Dunnet Properties Pty Ltd
Developers, Investors
ABN: 79 454 277 011

**RE: SD-77820496 – Submission
Sydney Olympic Park Metro Station Over and Adjacent Station Development – Concept
Amendment**

SSD-35283699 – Submission

Figure 2: Shadow diagrams illustrating the additional overshadowing caused by the proposed Amending Concept SSDA, which adversely impacts Site 50

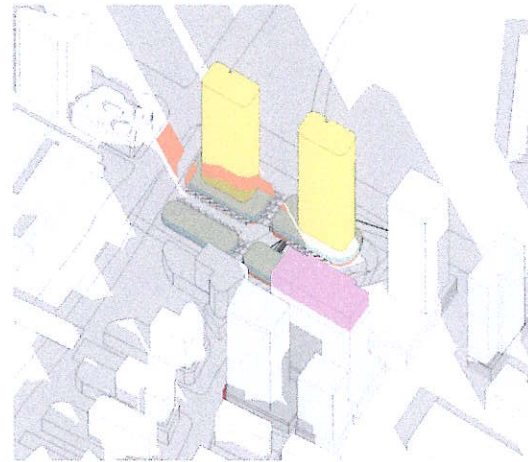
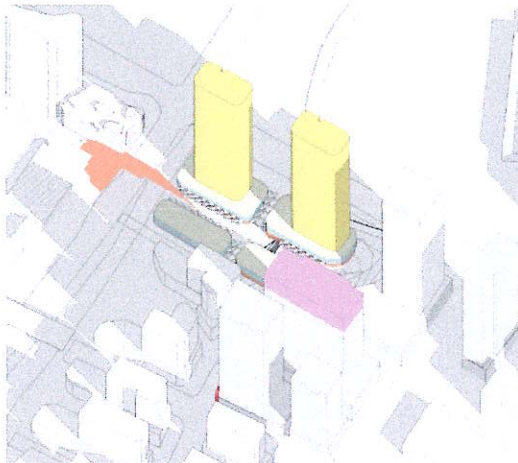
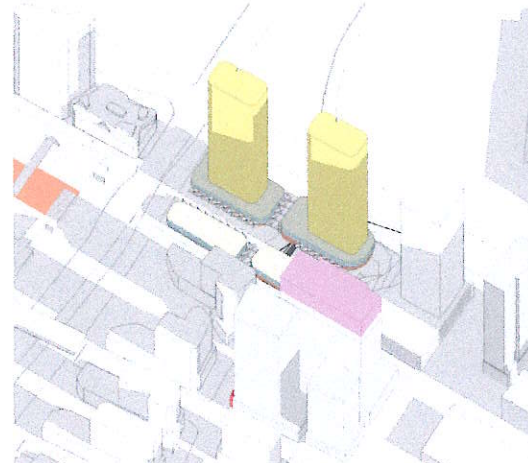
- The proposed additional height will cumulatively result in a considerable increase in overshadowing as illustrated in the Shadow Diagrams prepared by Curzon + Partners in relation to the reference design for the site (**Attachment B**). The additional shadow caused by the proposed Amending Concept SSDA is highlighted in orange in **Figure 2**.

- The apartments on the eastern and northern elevation of a future development on Site 50 are reliant on the morning sunlight to achieve at least 2 hours of solar access on the winter solstice. This is further eroded as a consequence of this proposal.

Recommendation 1: On the basis of the above points, Dunnet Group recommends that further work is undertaken in relation to the proposed Amending Concept SSDA including a reduction in building height and refinements to the envelope to remove any additional overshadowing impacts on Site 50 and allow for reduced overshadowing when compared to the approved Concept SSDA (SSD-35283699).

Figure 3: Central Precinct Land Uses Plan as set out in the Master Plan 2030

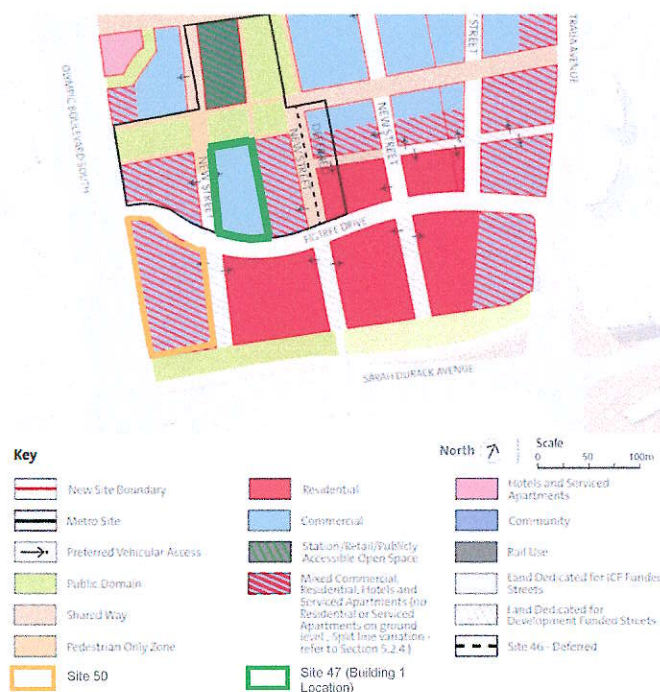
- The provision of only 13% non-residential uses on the site subject to the Amending Concept SSDA is contrary to the 'Commercial' classification of this part of the site in the currently applicable Master Plan 2030 (as shown in **Figure 3**) and the 'Mixed Use' classification of this site in the Draft Master Plan 2050. With Buildings 2 and 3 being residential, the achievement of a mixed use scheme across the Metro OSD site requires the maintenance of Building 1 as wholly commercial.

Recommendation 2: On the basis of the above points, Dunnet Group recommends that the proposed land use for Building 1 is maintained as commercial in line with the existing approval under the approved Concept SSDA (SSD-35283699).

Figure 2: Excerpts from overshadowing diagrams

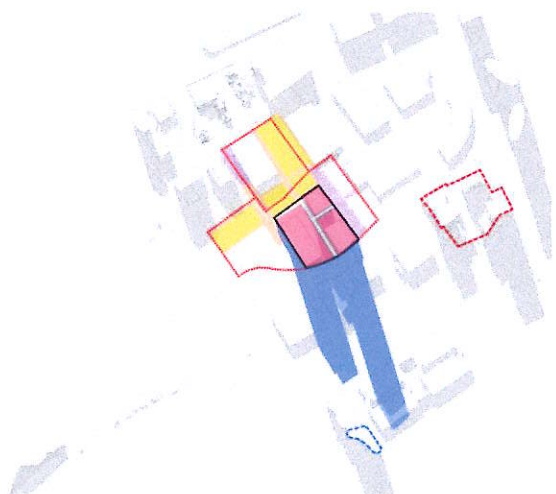
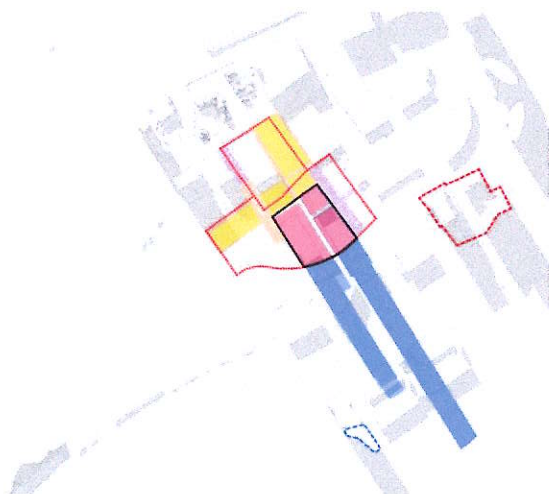
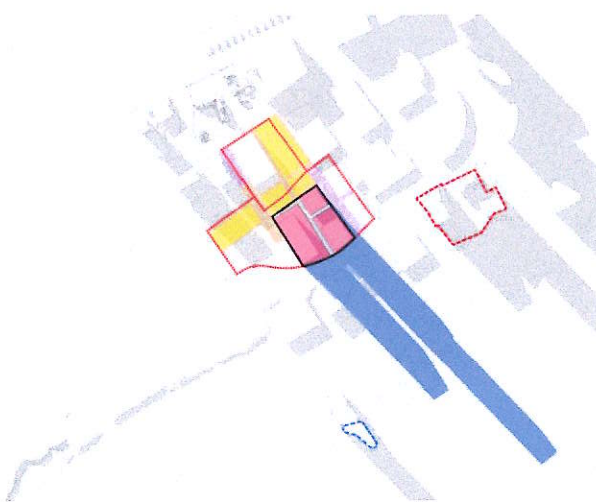
The proposed SSDA will result in significant overshadowing of Site 50 on the winter solstice from 9am through to 1pm, with vast impacts from 9am through to 12pm. This is demonstrated in the below extracts of the overshadowing diagrams submitted with the SSDA included at **Figure 2** below.

Figure 3: Cumulative overshadowing impact of Sites 47 and 48 on Site 50 – 9am on winter solstice

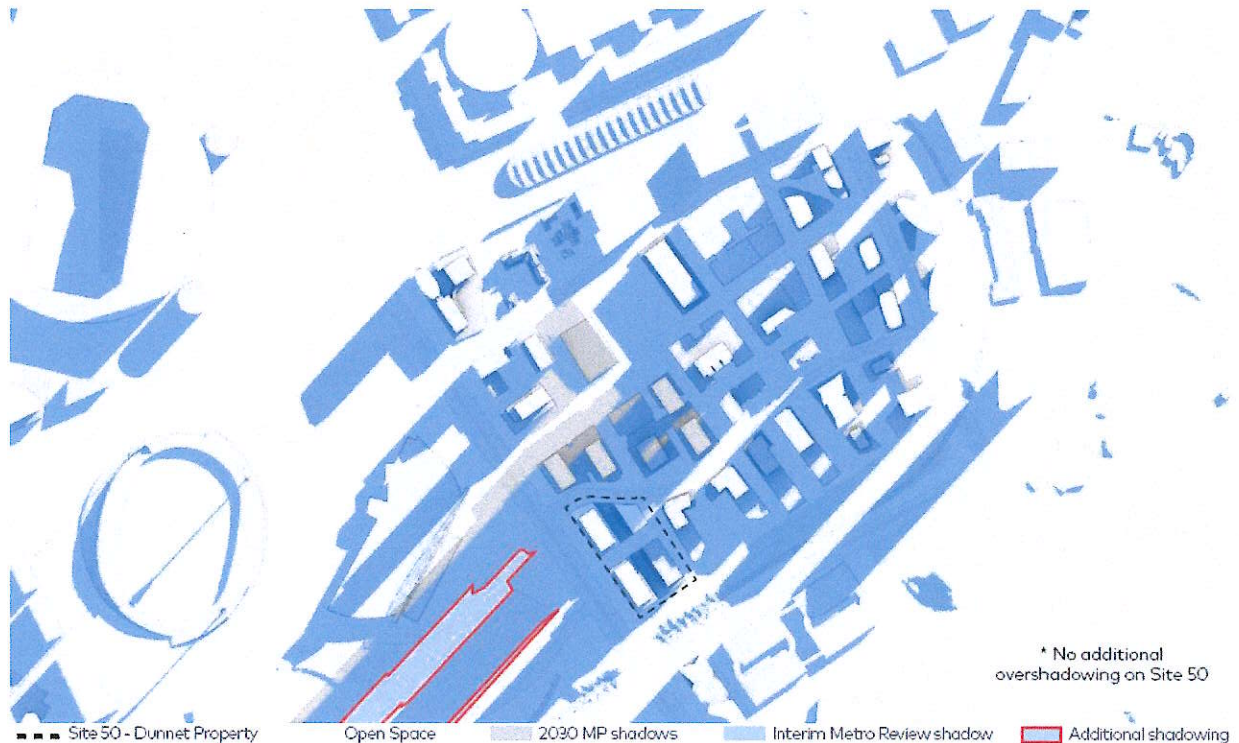
The cumulative shadow impacts caused by the proposed Concept SSDA and the future development on Site 48 will detrimentally impact the development potential of Site 50 in terms of maintaining acceptable levels of solar access to the podium and towers. This is especially harmful to the development potential of Site 50 given that the site is envisaged to be mixed use including significant components that will likely comprise a residential use. As such, given the significant all day cumulative overshadowing expected as a consequence of the Interim Metro Review of Site 47 and 48, further work is considered necessary for the Concept SSDA to mitigate the overshadowing impacts on Site 50.

As a result of the abovementioned shadow impacts that will be caused by the proposed SSDA, and the cumulative impact when also considering Site 48, it is strongly recommended that a sun access plane be adopted for Building 1 contained within the proposed Concept SSDA. The sun access plane is recommended
